Our Ref: DA/080/2023

SUBJECT LAND: 138 Maroubra Road, Maroubra
APPLICATION NO: DA/080/2023
PROPOSAL: Demolition of existing structures and construction of a 9-storey mixed-use development with 3 basement levels comprising 57 units, retail and commercial tenancies, 89 car parking spaces and strata subdivision. (Integrated Development: Approval required by Water NSW).

REQUEST FOR ADDITIONAL INFORMATION (FOLLOWUP LETTER)

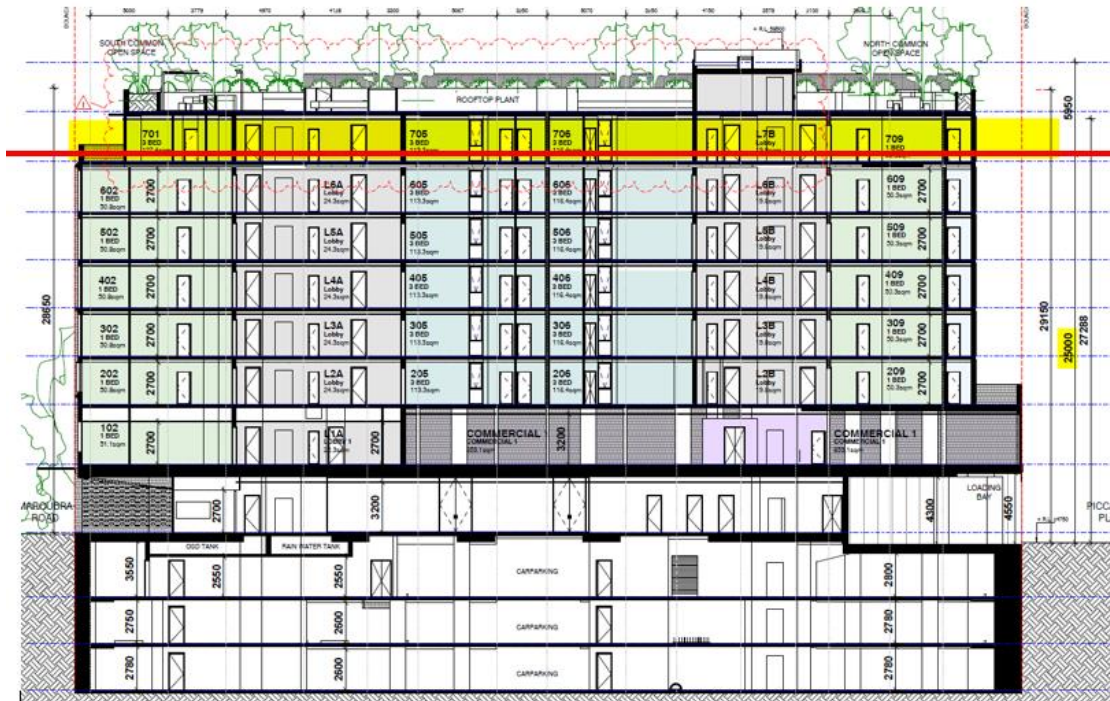
- g. Plans are to reflect desired internal floor-to-ceilings. As the floor plans appear to accommodate food and drink premises (kitchen exhausts, grease arrestor etc are noted) the ADG stipulates a FL-CL of 3.3m or 4m. A minimum of 3.3m could be accommodated for Level 1 to permit a range of permissible commercial uses (noting this would affect height: to be resolved per other points raised throughout this letter).

- h. Given recent changes due to the NCC and Building Commissioner, a minimum of 3.15-3.2m is now required for floor to floor heights in residential levels to achieve 2.7m ceiling heights – the 3.1m's indicated is insufficient and has not been demonstrated to be workable.

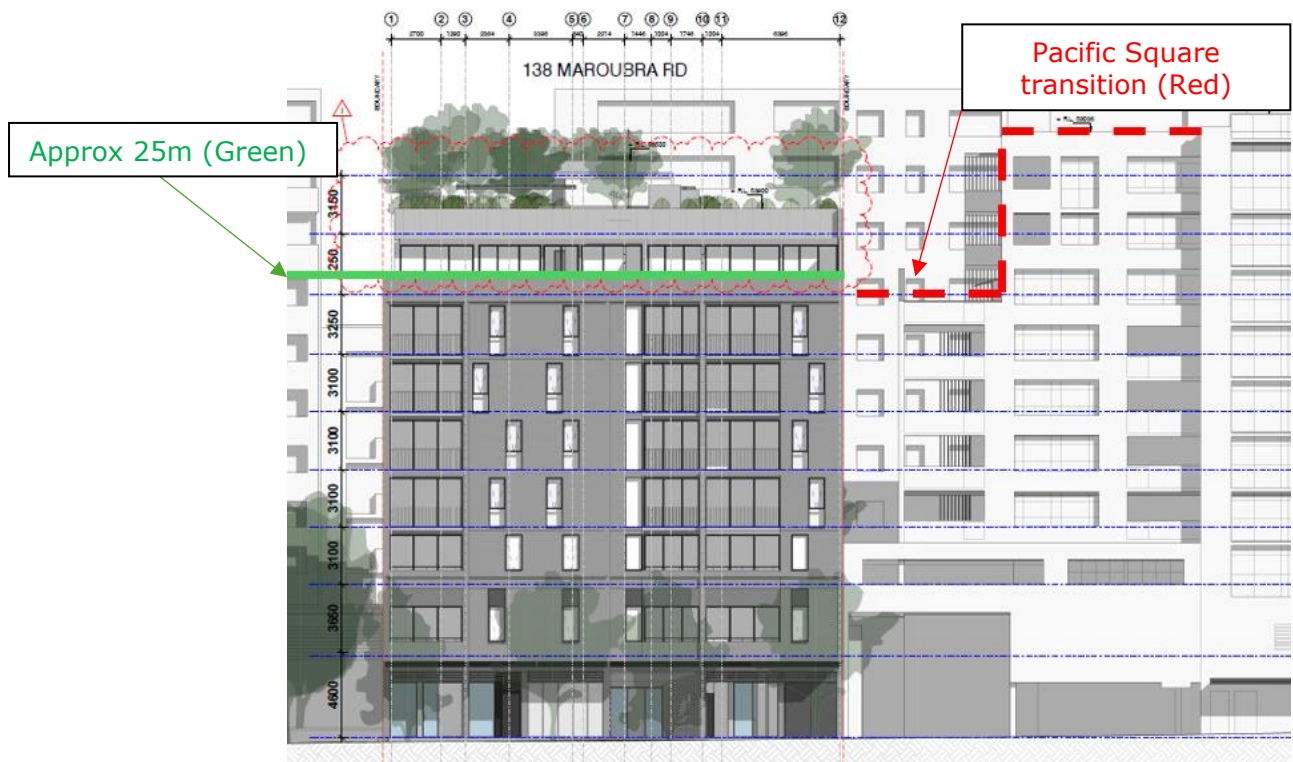
The submitted Clause 4.6 incorrectly identifies that there is no additional habitable floor area over the height of buildings control. However, it is evident that the proposal is one (1) storey of habitable floor over the height control, in

addition to 1 (one) storey of communal rooftop access, for a total of two (2) storeys over the building height control. Level 7 (storey 8) and above contributes to the height variation and magnification of scale and density of the development.

The intention of the controls applicable to new development, including the height standard applicable to the lot, is to provide a transition. The transition is initiated by the western elevation of “Pacific Square” fronting Maroubra Road, which is 6-7 storeys:

The proposed development is to be amended to achieve this transition and more appropriately respond to the applicable building height standard. A height variation solely to accommodate rooftop communal open space can be considered by Council, however, this is also subject to demonstrating adequate amenity outcomes concerning solar access (sunlight/overshadowing), views, and visual and acoustic privacy in accordance with the other matters raised in this letter.
